Product hierarchy no. *				Part no.	SBU	Type / Description	Customer part no.
SBU	PG	PUG	Type				
02	007	003	0000002298	See list below	Appliance Inlet	4798

Product Change Notification					PCN 4798		
owner	creation date	release date	released by	change order no	rev	page	D10-014-610
sariogar	2017-04-24	2017-04-24	sariogar	2012718	B	1 of 1

1 Products affected

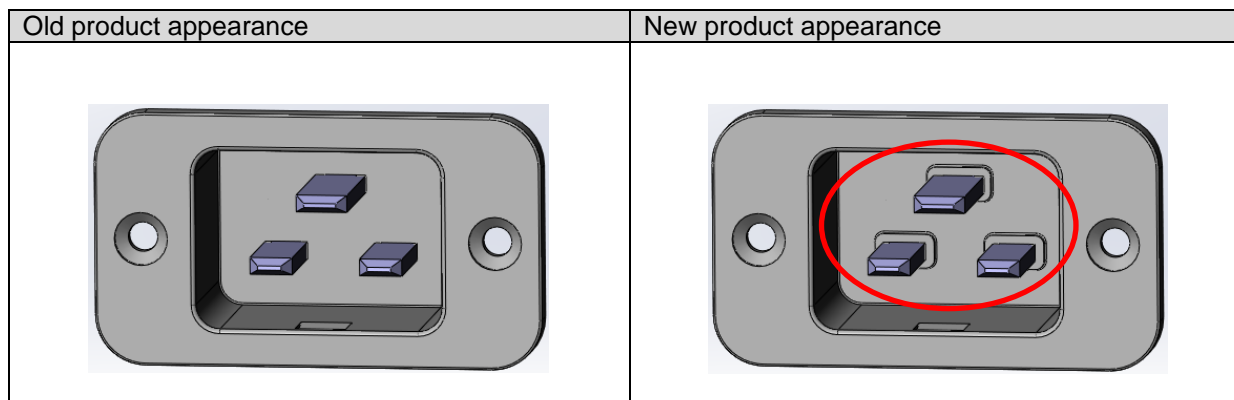
The socket base will be lowered by 0.8 mm. The collars around the terminals guarantee compliance with the IEC dimensions.

The socket base has to be adapted for intended versions with IP54 protection against connector.
